# Technical Design Note

**Project:** Kariong Sand and Soil  
**Subject:** Request for Further Information  
**Date:** 10 December 2020  
**Attention:** Mark Jackson – Jackson Environment and Planning

Comments from peer review by Intersect

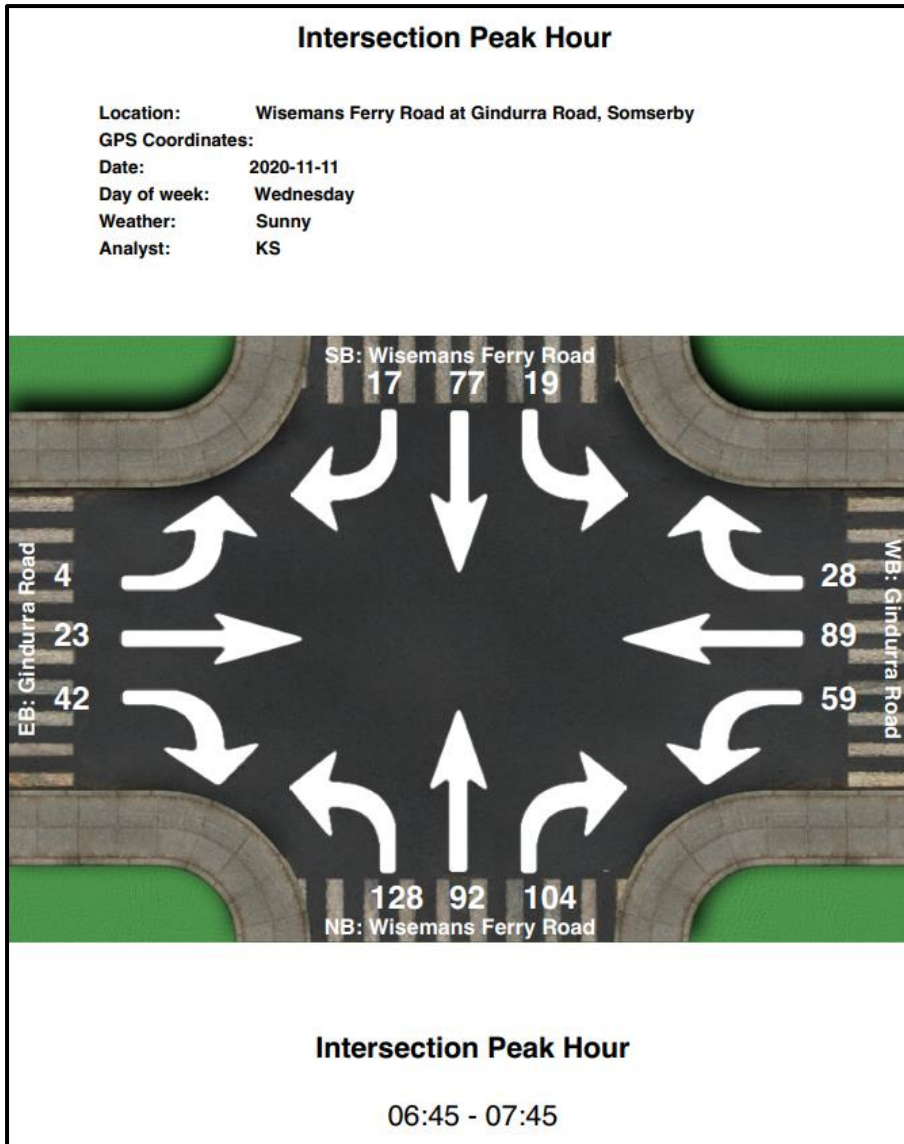
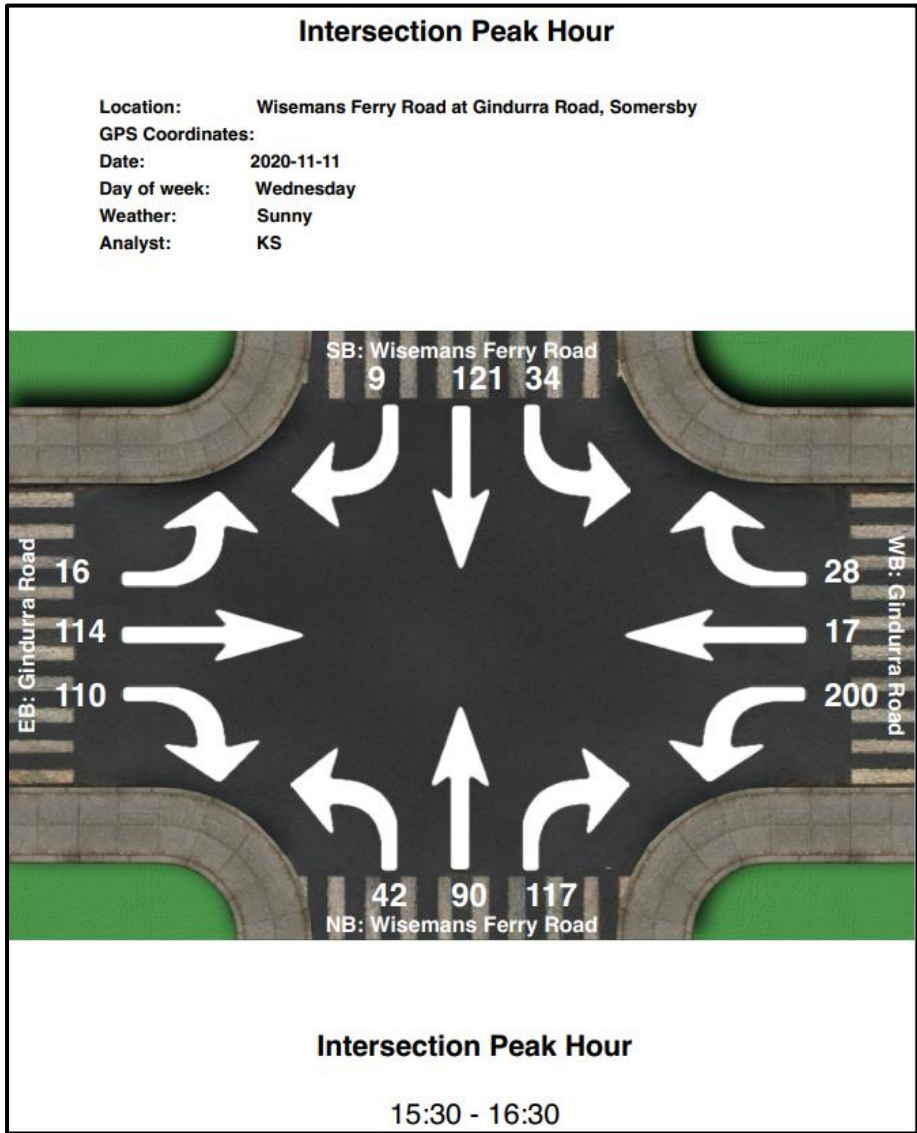
<p>Queuing of vehicles on the road network. In the Kariong Sand and Soil report there is a general statement that vehicles will arrive once every 5 minutes therefore two queuing spaces should be enough, but they do not prove it. No detail on service times or length of stays for vehicles or the internal capacity of the site to cater for vehicles has been provided. Also in a peak hour there will actually be a vehicle arriving every 3 minutes (21 vtpH) so the report has not addressed peak hour traffic from a queuing perspective and the queue lengths could be predicted using queuing theory to determine if there is enough queuing area on the site such that queuing trucks will not impede traffic on Gindurra Road. Therefore I am of the opinion the report does not prove there is enough queuing space on-site.</p>	<p>Typical time for vehicles using the weigh bridge is less than 2 minutes, allowing for vehicle to stop, weight noted and driver details taken etc.</p> <p>Assuming an equal split of vehicle arrivals, there will be a single vehicle waiting prior to the weighbridge, when there is a truck already on the weighbridge.</p> <p>There will not be more than 2 trucks arriving at any one time to the site.</p> <p>The layout of the site provides 60 metres between the entry point of the site and weighbridge. A truck and dog combination is 19 metres, therefore with a vehicle on the weighbridge there is adequate space for 3 further truck+dog combinations to be parked on site. Given the spread of arrivals across a typical hour there will not be 4 trucks all arriving at the same time and as such there will not be a queue back onto Gindurra Road.</p>

<p>The traffic data used for the traffic assessment is 5 years old. For an important development like this current traffic data should be used. Whilst it is understood undertaking traffic counts in June and July this year would have resulted in reduced traffic volumes due to the impacts of COVID 19 and the requirement to isolate as much as possible. However traffic volumes are now considered to be close enough to pre COVID volumes for traffic counting to recommence. Given the amount and type of traffic generated by this development I would have thought Council and TfNSW should be requiring that updated traffic</p>	<p>Updated traffic surveys and Sidra modelling completed. This assessment allowed for the traffic flows associated with the subject site as well as the proposed warehouse development at 83 Gindurra Road (located opposite the subject site).</p> <p>See Sidra assessment below.</p>

<p>counts be used in this assessment.</p>	
<p>I am not sure that the measures to stop vehicles heading through the rural residential area to the east is sufficient. At the moment they are only suggesting signposting at the access. I think new load limit signs and enforcement should occur to the east of the site and the development should ensure all heavy vehicle drivers using the site are aware of and sign off on a driver code of conduct for the development.</p>	<p>A drivers code of conduct shall be developed in conjunction with a traffic management plan. This drivers code of conduct will include details on the access route in and out of the site and highlight that heavy vehicles are not permitted to turn right out of the site. The central median in the driveway also directs drivers to turn left out of the site only.</p> <p>Signs will be provided at the site exit point to the site to remind drivers of heavy vehicle to turn left out of the site only.</p>

<p>Both traffic impact reports do not appear to have considered the cumulative impacts of other development in the area, not the least being the cumulative impacts of traffic from the other development. Whilst they consider the impacts of their own traffic generation at least one of the reports should consider the impacts of the combined traffic from both developments. This has not been done and given the same consultant was used for each report it would have been easy for this to be done.</p>	<p>Updated Sidra assessment completed. See below.</p>
<p>It is noted that the Sidra modelling was done for 2017 traffic, yet the report was dated July 2020. It is my opinion that the modelling should have been undertaken for 2020 conditions including the cumulative impacts of both developments. While this is unlikely to have a major impact on the operation of the Wiseman’s Ferry Road / Gindurra Road roundabout it may not be the case with the Central Coast Highway / Wiseman’s Ferry Road traffic signals where an overall LoS C already exists.</p>	<p>New traffic surveys completed at Wisemans Ferry Road and Gindurra Road. Sidra modelling provided below for the current 2020 and future 2030 scenario.</p> <p>The intersection of Wisemans Ferry Road and Central Coast Highway has not been assessed in detail for this project. The volume of traffic associated with the project represents a very minor increase in the overall traffic flows in this location, with the major flow on the Central Coast Highway provided with priority at this location. In the AM peak there could be 21 vehicles associated with this project using this intersection. In the PM peak there would be 9.</p> <p>It is understood that TfNSW monitor this intersection and the traffic signals / layout have been maximised by TfNSW to accommodate the traffic flows at this intersection. TfNSW have also upgraded the M1 Pacific Highway to increase the number of traffic lanes in this location and the impact of the upgrade has been modelled. It is considered that this would include the signal-controlled intersection of the Central Coast Highway and Wisemans Ferry Road.</p>

<p>Further it is usual to undertake traffic impact assessments over a horizon period of 10 years and as such Sidra modelling of at least the Central Coast Highway / Wiseman’s Ferry Road traffic signals for the 2030 traffic conditions</p>	<p>The volume of traffic associated with the two separate projects shall have a minor impact upon the overall operation of this intersection. No Sidra modelling is considered to be required for this intersection. The volume of traffic will see a minor increase in flows at this location. It is further noted that drivers of light</p>

**Attachment A – Traffic data at Central Coast Highway and Kangoo Road**

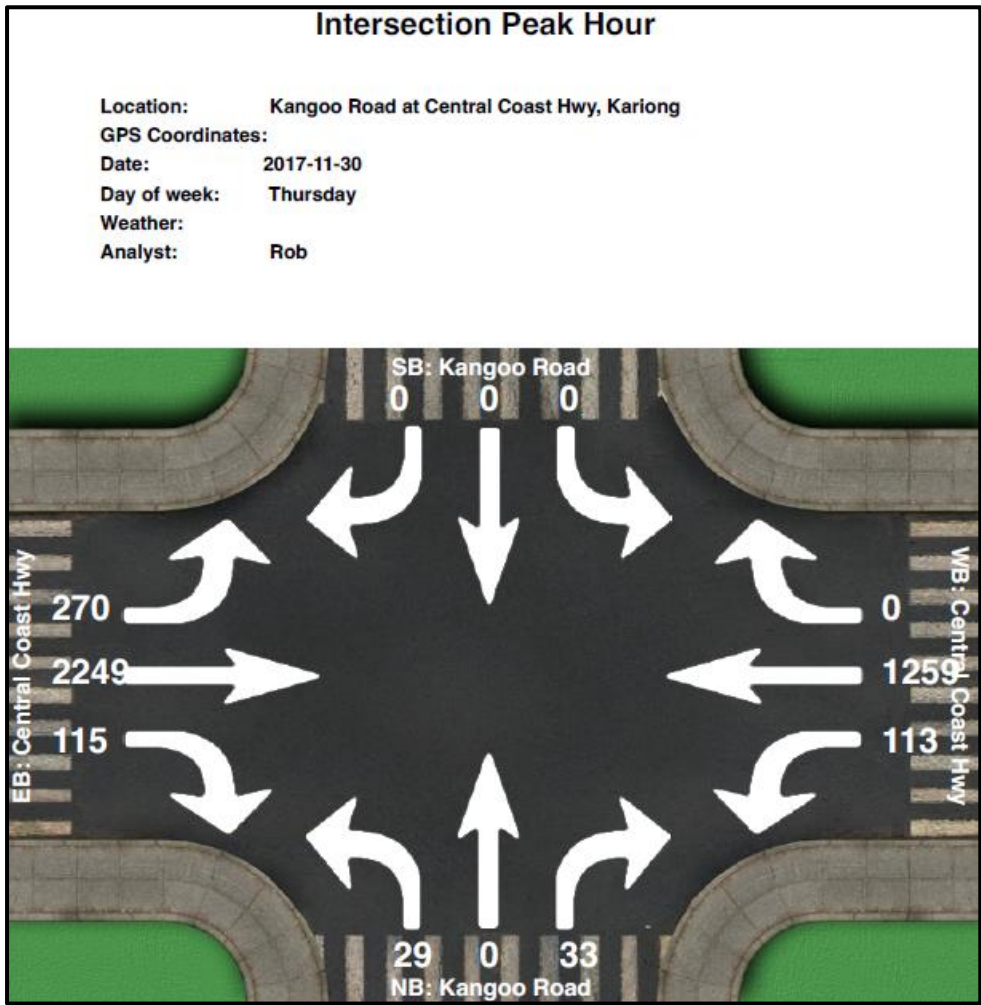
<p>The Traffic Impact Assessment (TIA) states traffic surveys were undertaken at Central Coast Highway/Kangoo Road and Central Coast Highway/Wisemans Ferry Road intersections. Please provide traffic survey result of Central Coast Highway/Kangoo Road intersection for the completeness of the report.</p>	<p>These surveys were included in pages 36 and 37 Appendix E of the report.</p> <p>Re-attached to this RFI</p>
<p>The TIA should assess the worst-case scenario when waste delivery vehicles from south using Central Coast Highway/Kangoo Road intersection and its impacts on the intersection performance.</p>	<p>Waste delivery vehicles will not use Kangoo Road due to weight limit. All heavy vehicles will access the site via Wisemans Ferry Road / Gindurra Road.</p>
<p>The TIA does not detail the proposed management measures for prohibiting waste delivery vehicles using Kangoo Road, Acacia Road and Debenham Road South to access the site. Please detail the management measures in the RtS.</p>	<p>A Driver Code of Contact shall be included in the Traffic Management Plan for the site and provided to all staff as part of the driver / contractor training to be provided</p>
